APPENDIX 9-A REVISED

OPRHP Correspondence

Project: Somersset Solar Project (140-200 MW/? acres)

PR#: 21PR00981

1 COMBINER BOX SIDE ELEVATION - TRACKERS
SCALE: NTS

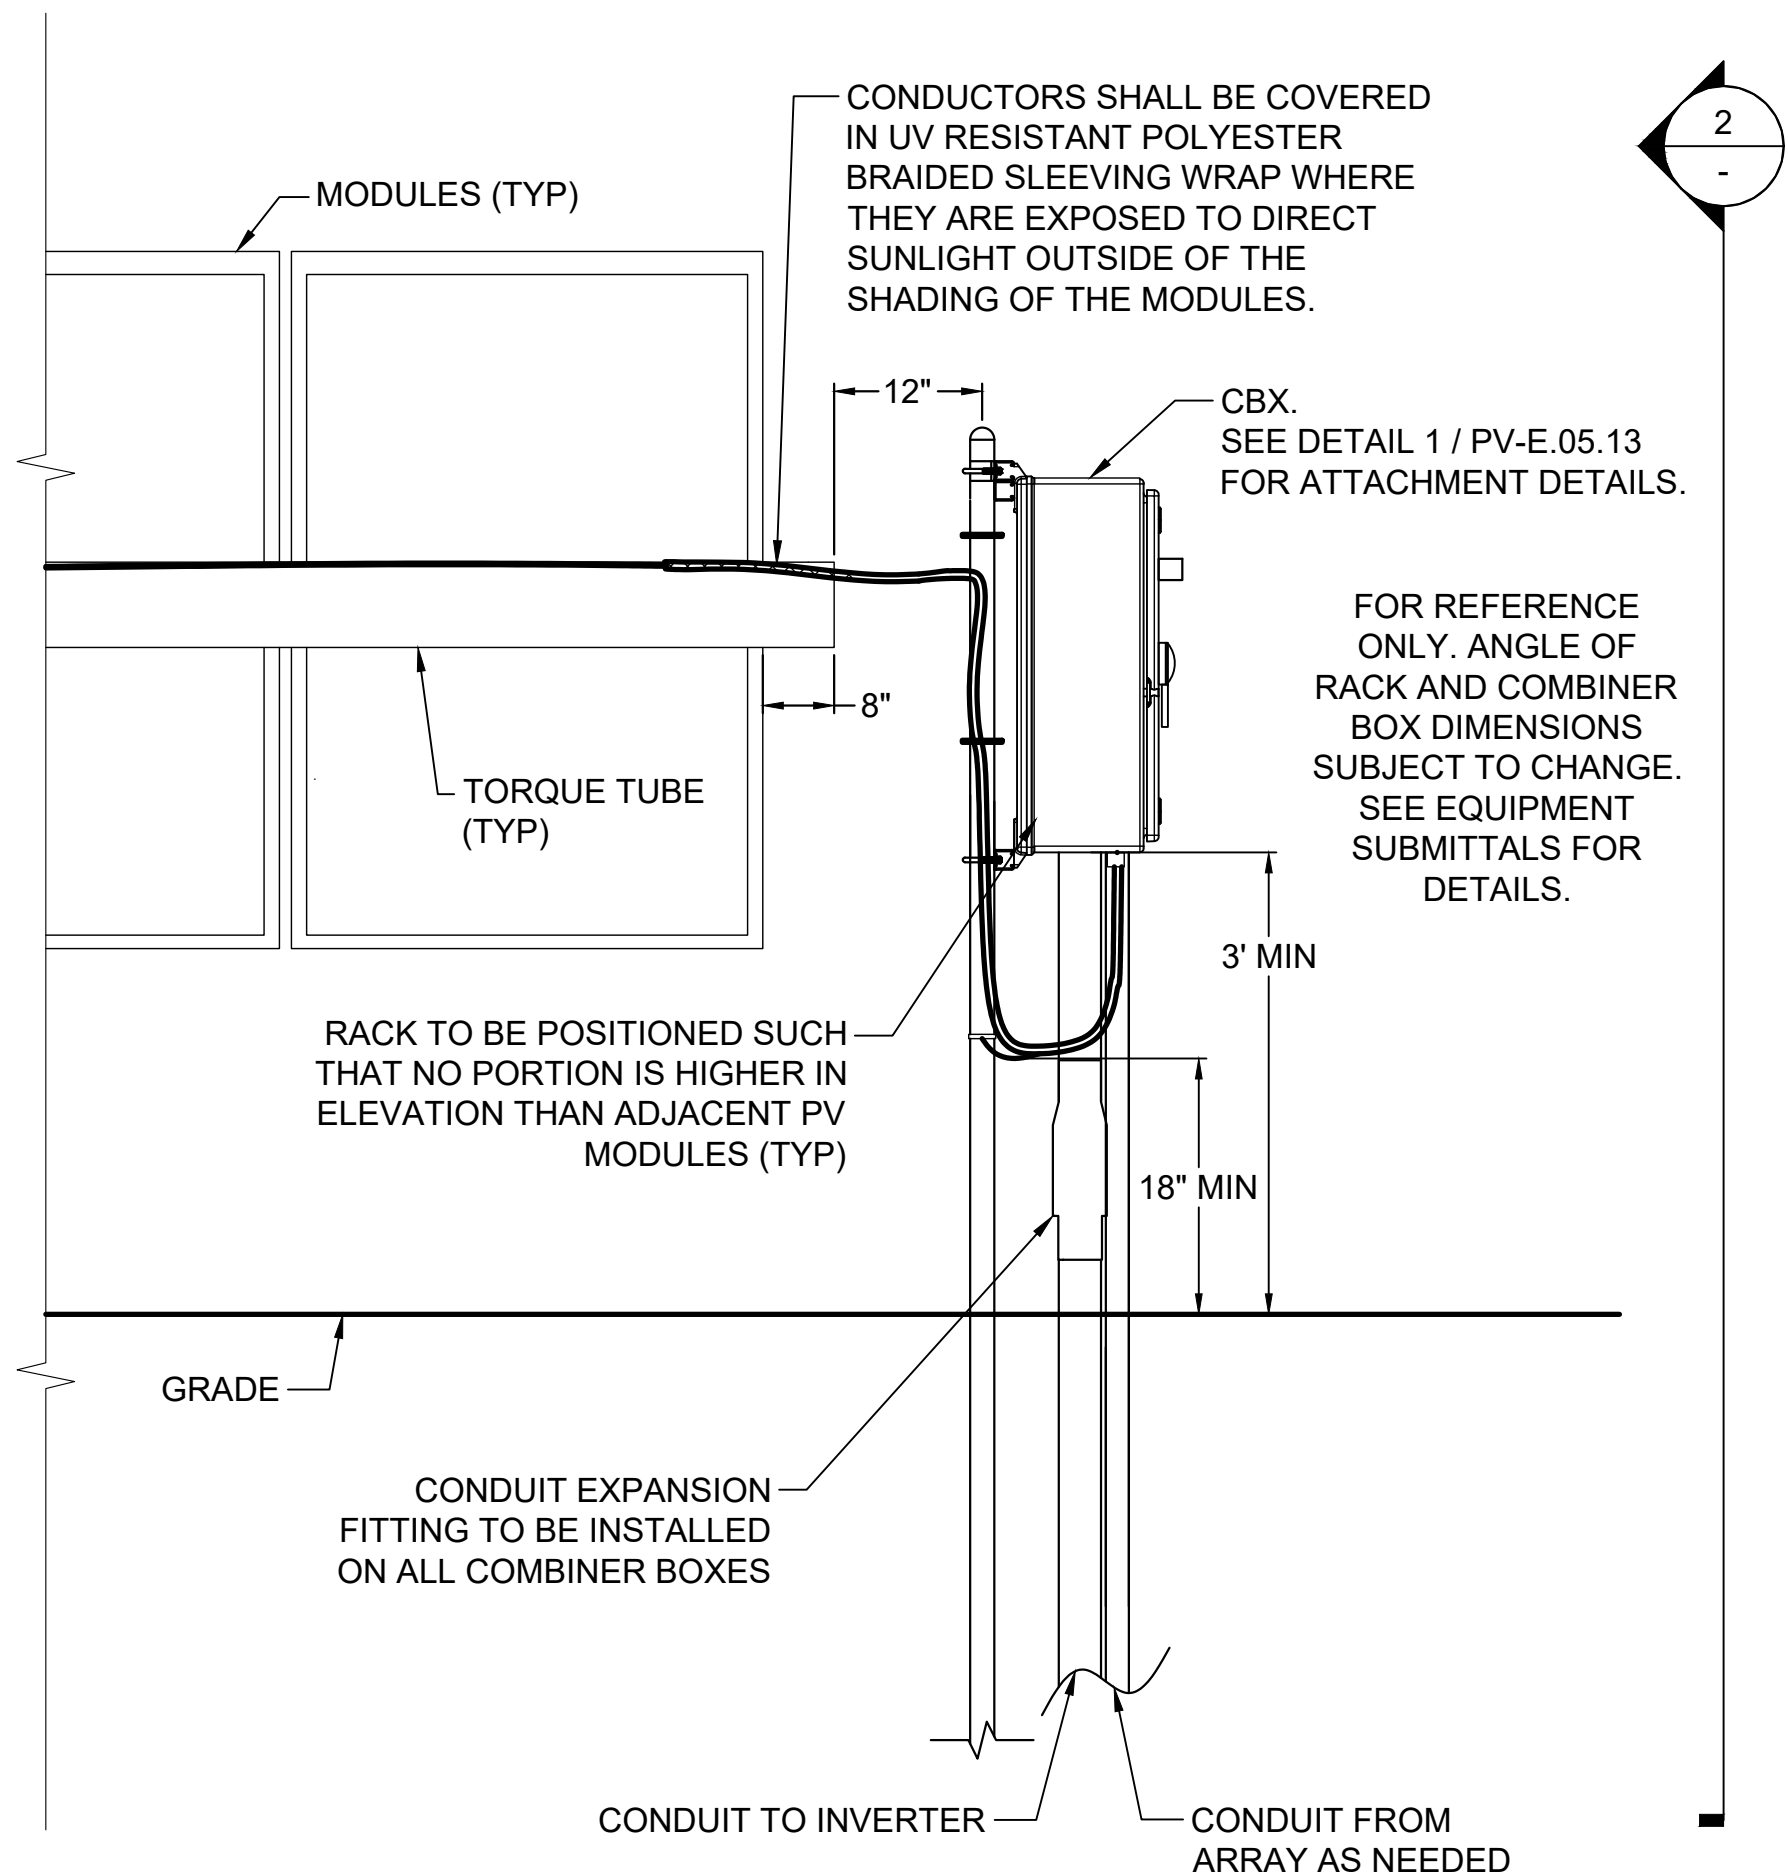
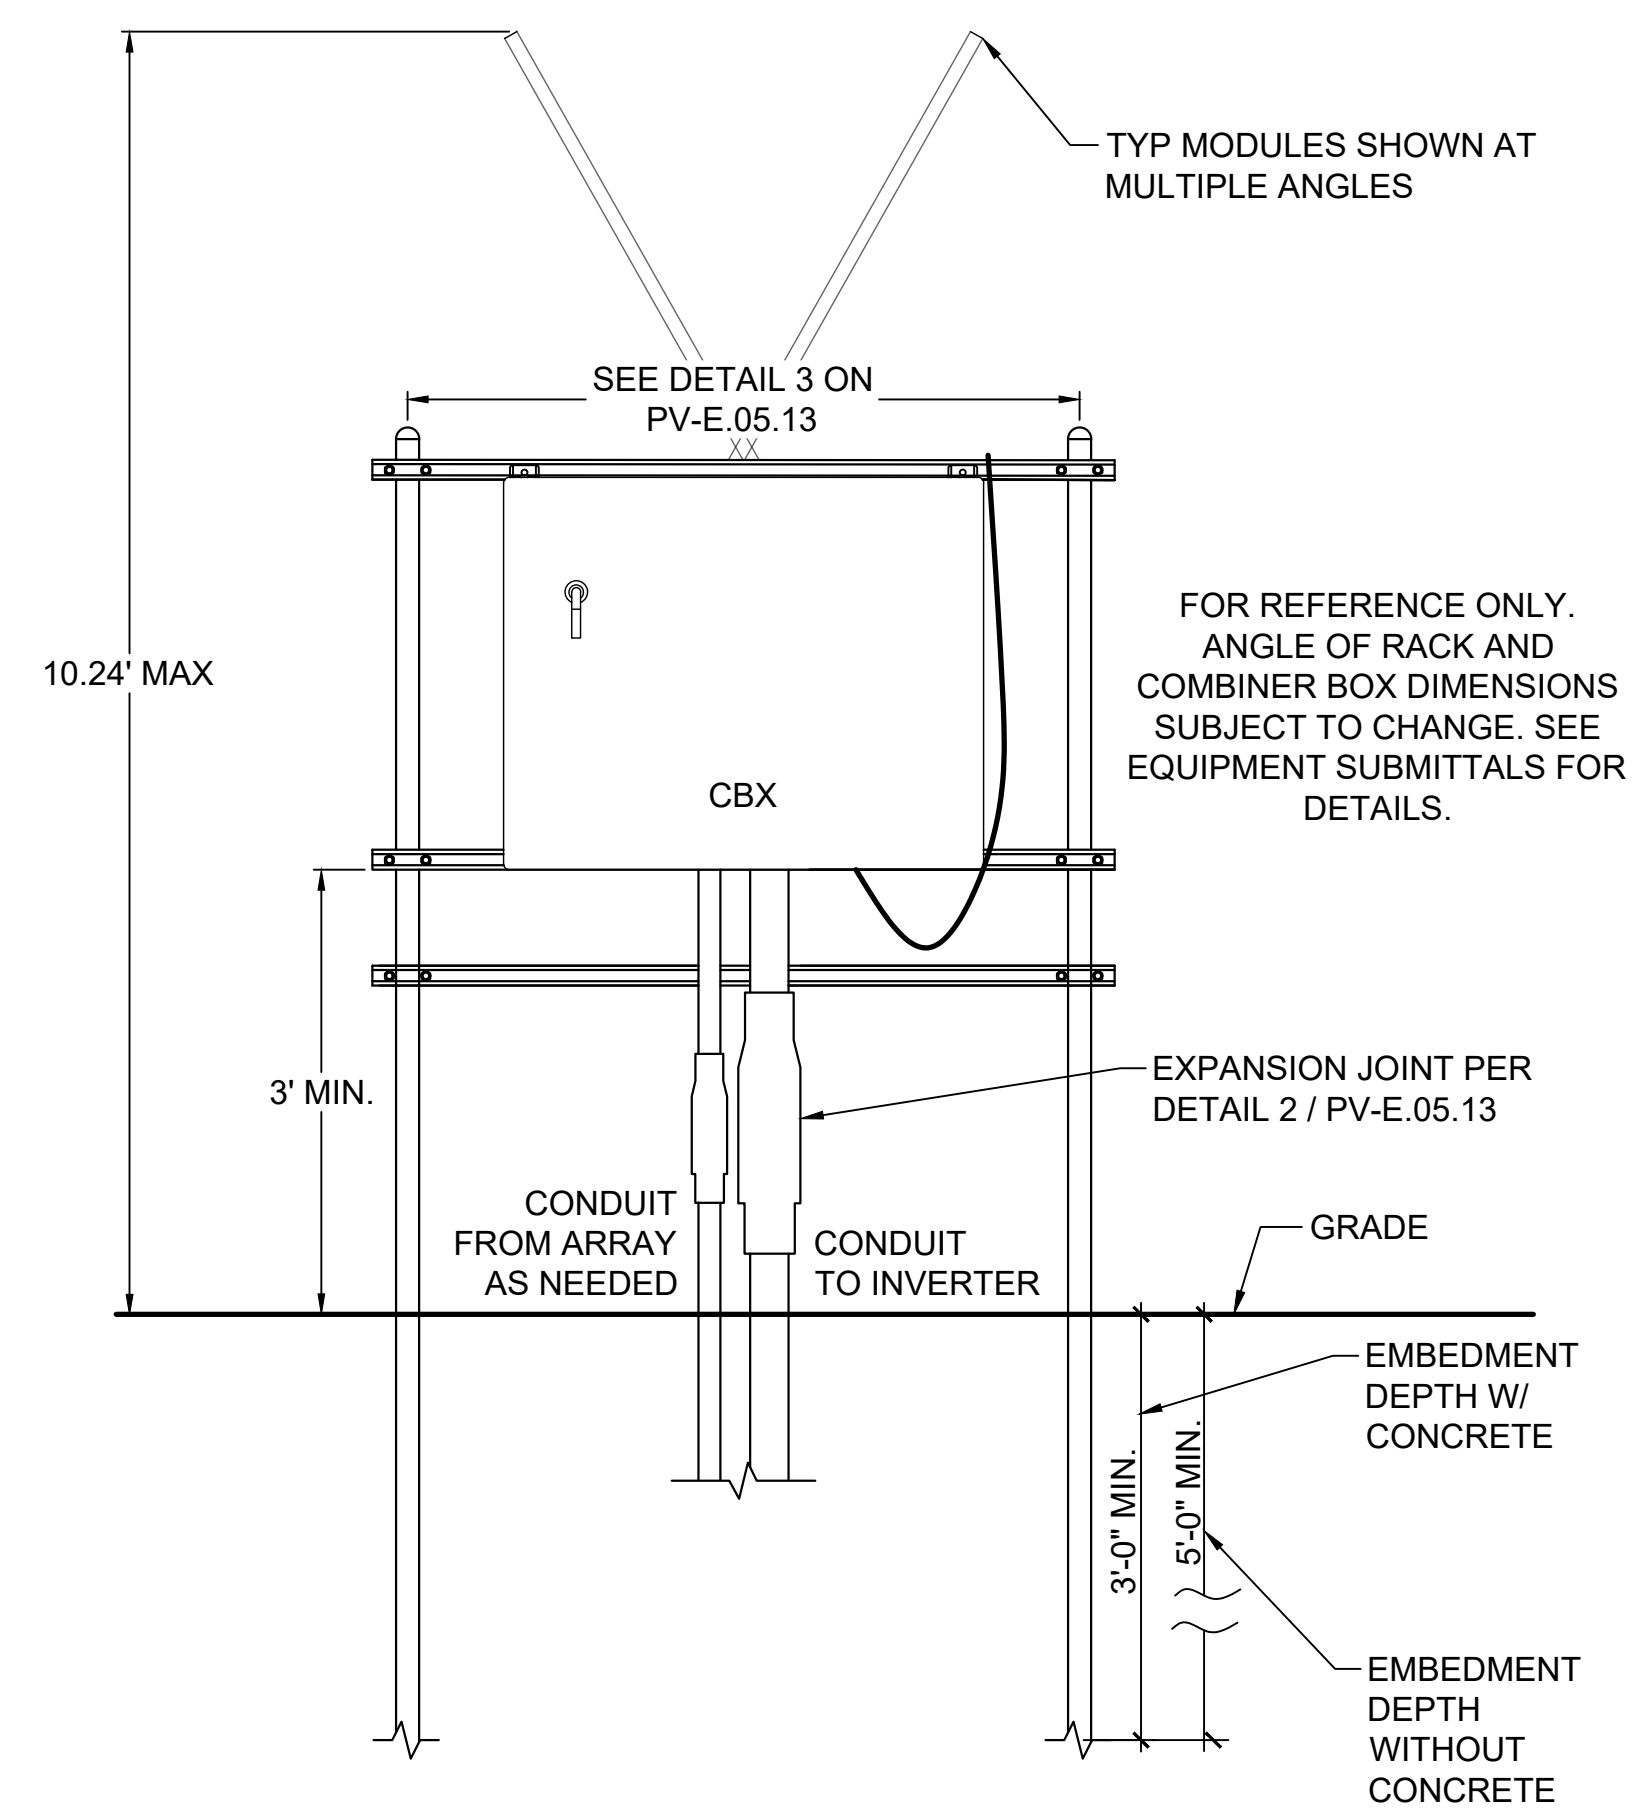
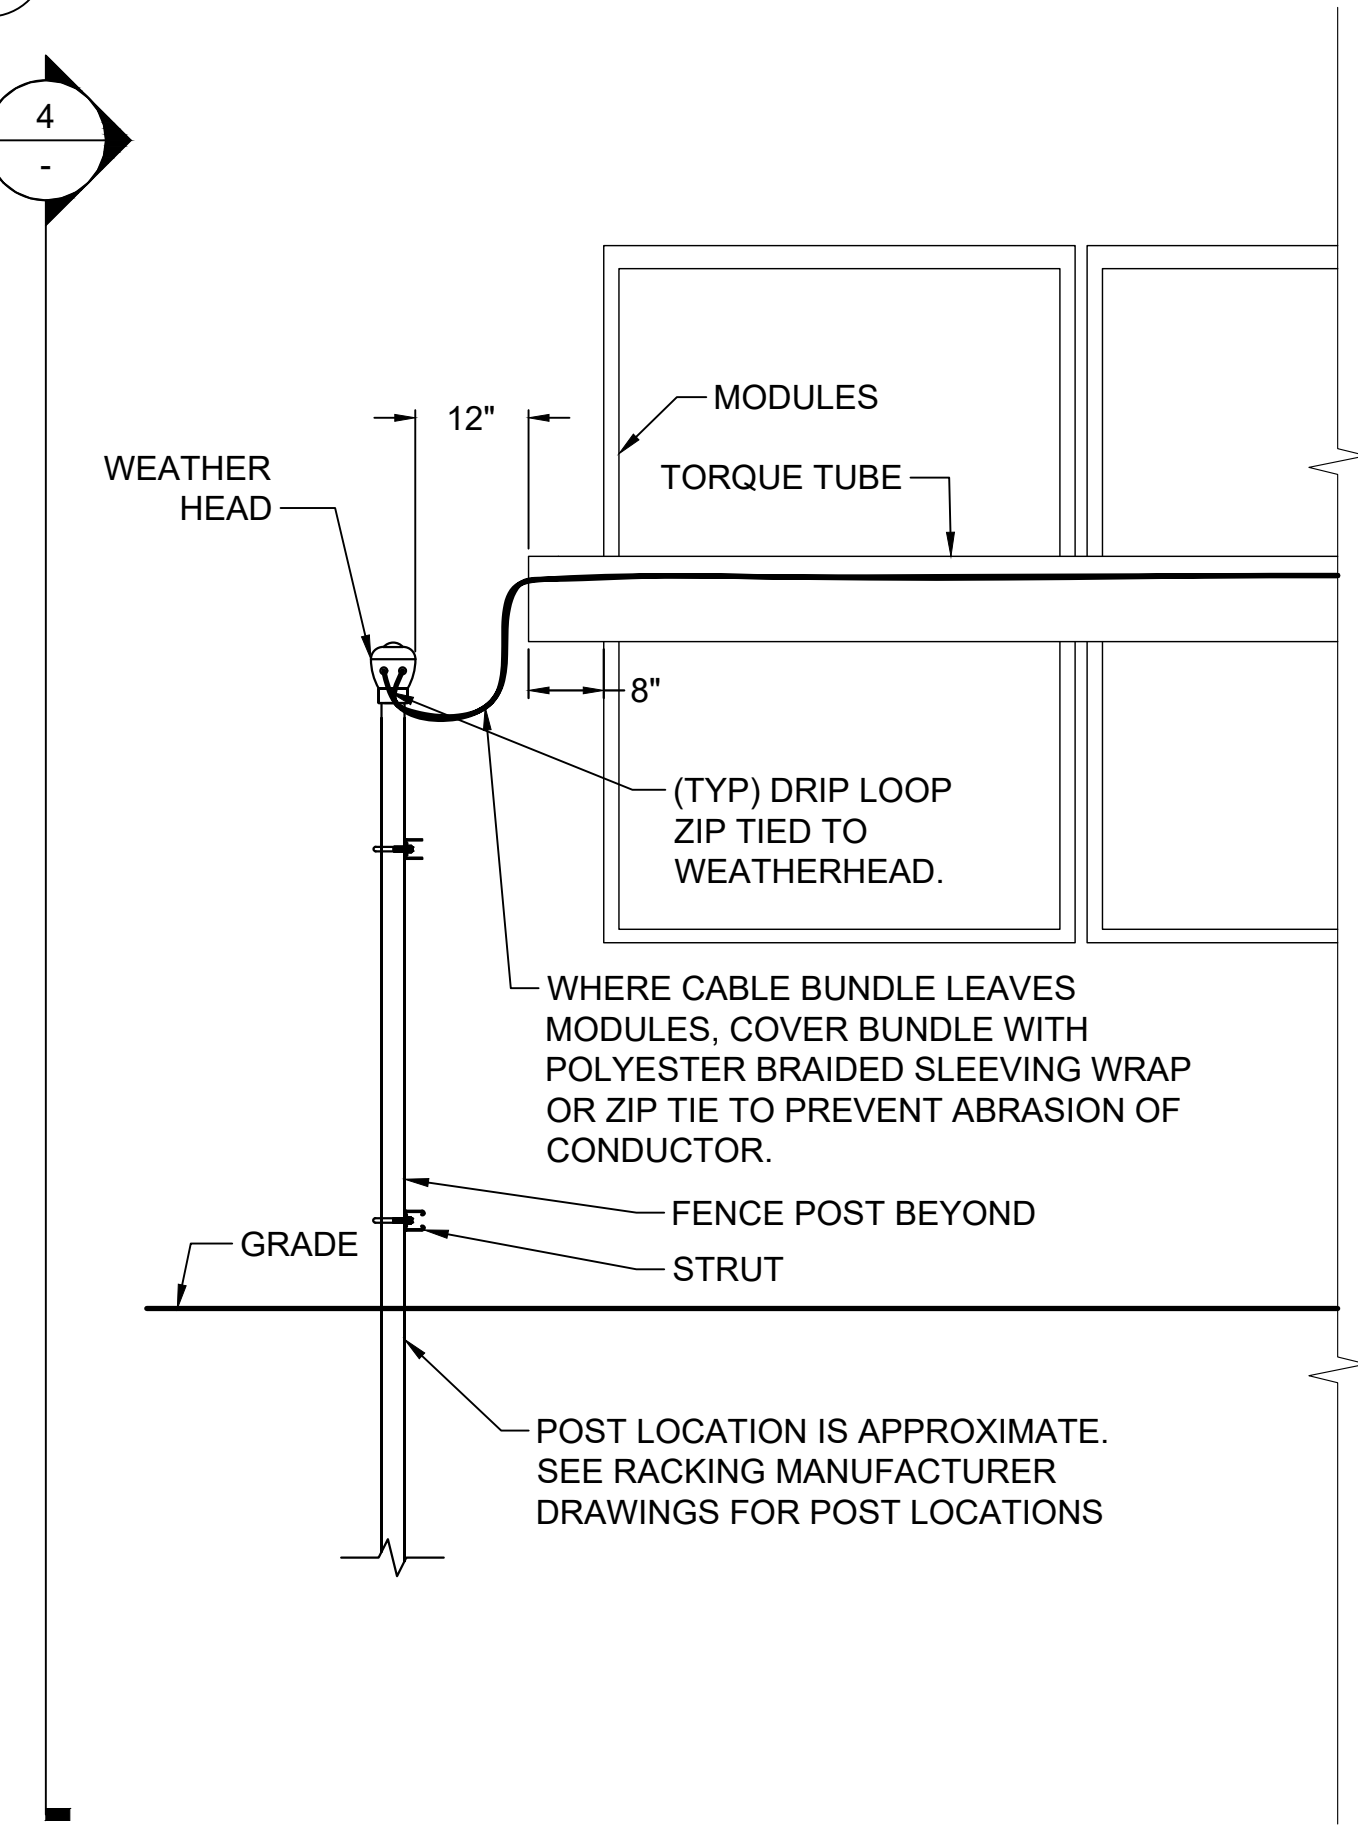
1. Detailed site plans showing solar panels, access roads, and other features, as well as any existing or proposed vegetative or topographic buffers, in the immediate vicinity of the Smith Residence and Babcock House. (It is useful for these plans to be superimposed with satellite or orthographic images.) Please also include, elevation drawings of the solar panels indicating maximum panel height and direction of rotation.

Response: The requested site plans (superimposed over aerial imagery) and elevation drawings are included in Attachment A, and include a site plan overview (PV-C.02.00), site plans for the Facility areas in the vicinity of Smith Residence (PV-C.02.01) and Babcock House (PV-C.02.02), and Conduit Management Standards (1 of 3 and 2 of 3) (PV-E.05.11 and PV-E.05.12). Both fixed tilt and single-axis panels are proposed, with fixed tilt panels having a maximum height of 7.14 feet from grade, and single-axis panels having a maximum height of 10.24 feet (maximum) from grade. The single-axis panels will be
